#### **AMENDMENTS TO THE DRAWINGS:**

## **REMARKS**

### **Objection to the Drawings**

FIG. 2

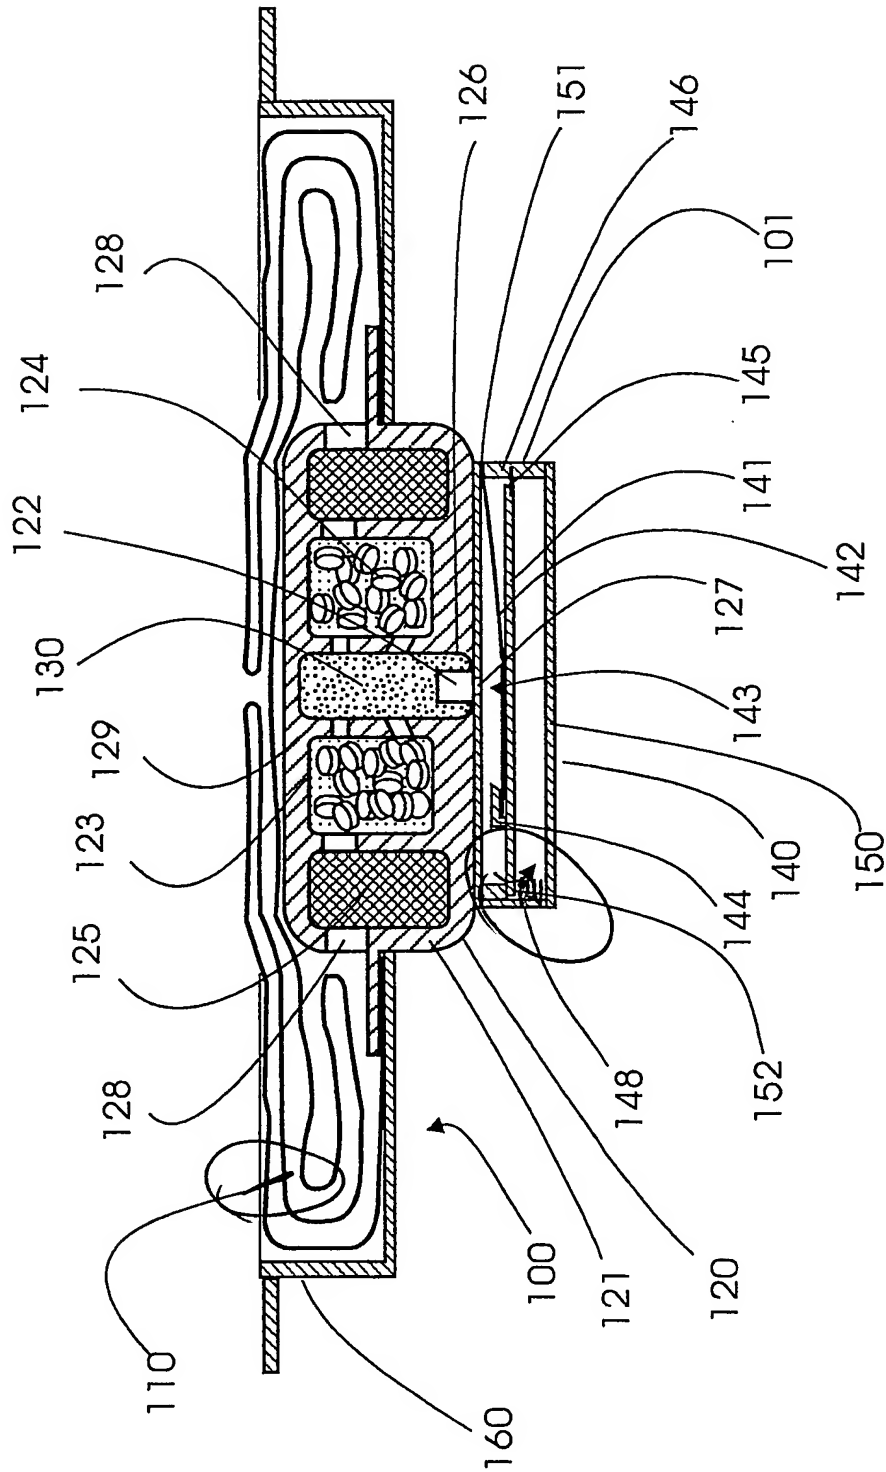
In Fig. 2, the lead line for reference numeral 110 now touches the airbag and the lead line for reference numeral 152 now points to a clearance between the walls 146, 148 and the sensing mass 141.

Fig. 10

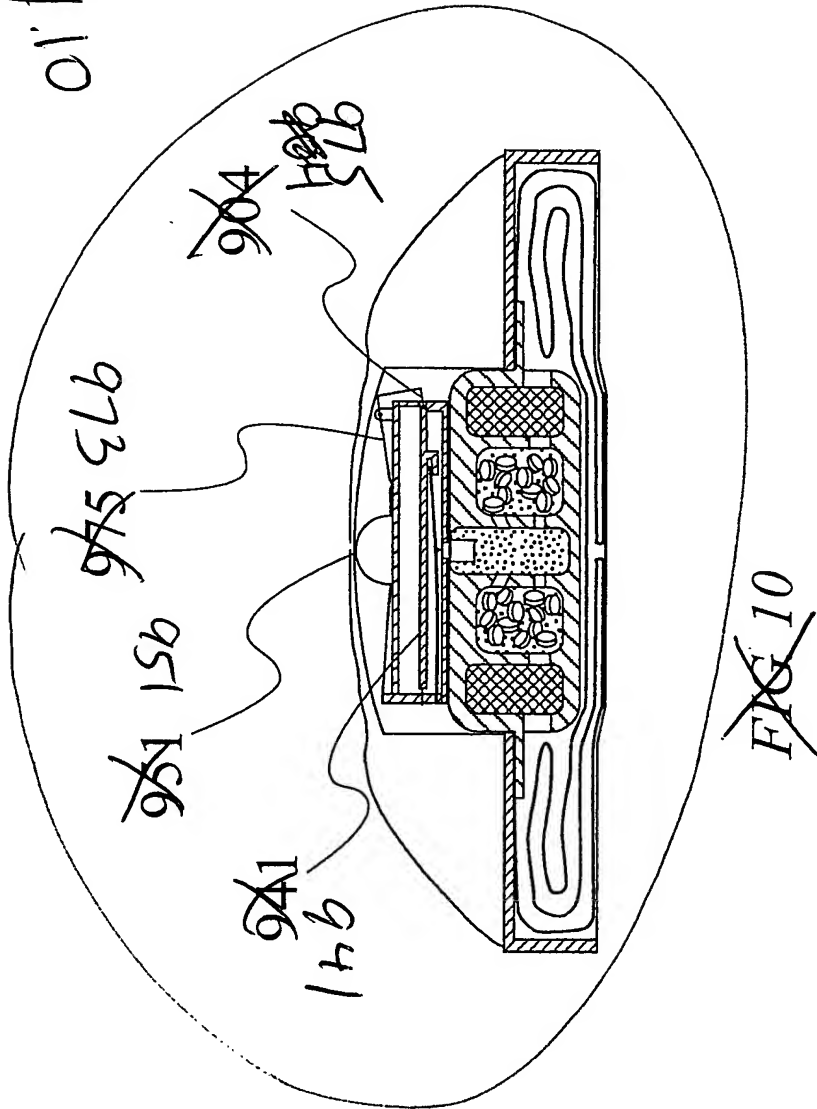
In Fig. 10, the reference numeral for the lead line pointing to the lever is now 973 and the reference numeral for the lead line pointing to the end of the lever is now 975. Also, Fig. 10 is inverted to be in the correct orientation relative to Fig. 9.

Fig. 10A

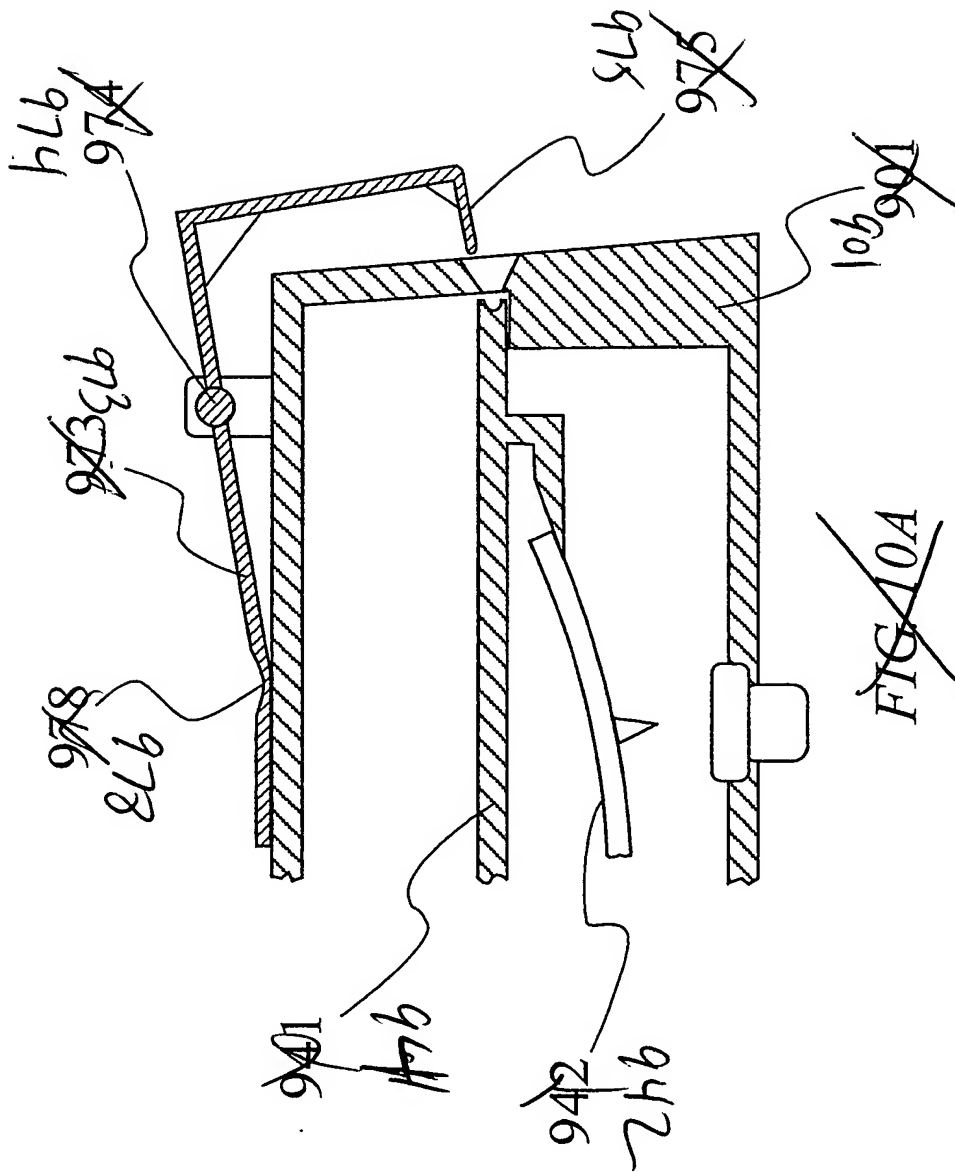
Fig. 10A is inverted to be in the correct orientation relative to Fig. 9.

FIG. 13

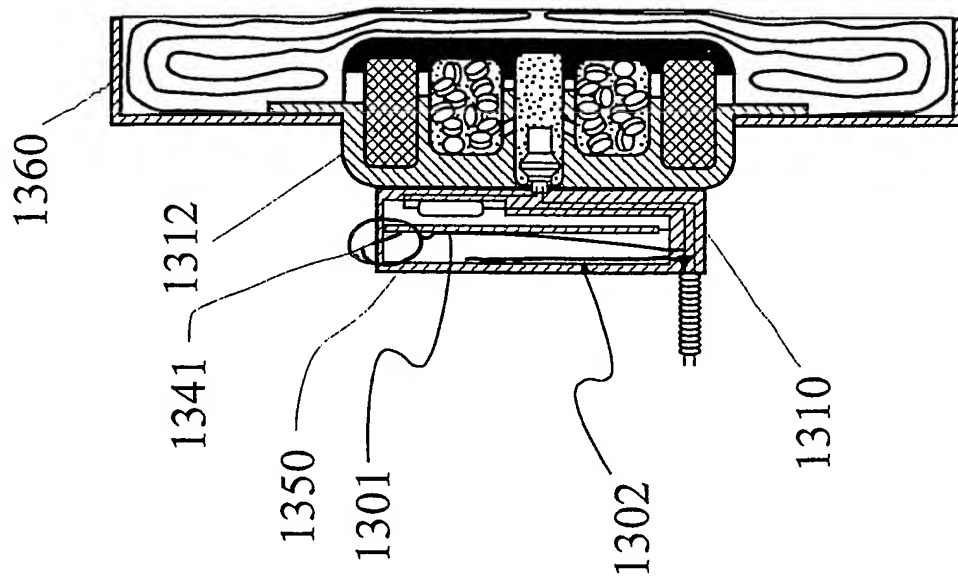
In Fig. 13, the contact 1302 is now better shown on the inside of the top cover 1350 of the sensor housing 1310 along with a clearer separation between contacts 1301 and 1302. Also, the lead line for reference numeral 1341 now points to the sensing mass.

With respect to the embodiment shown in Fig. 13, it is respectfully submitted that it was inherent if not readily ascertainable that the contact 1302 was on the inside of the top cover 1350 of the sensor housing 1310, which is the only position in which it could be contacted by the movable contact 1301.
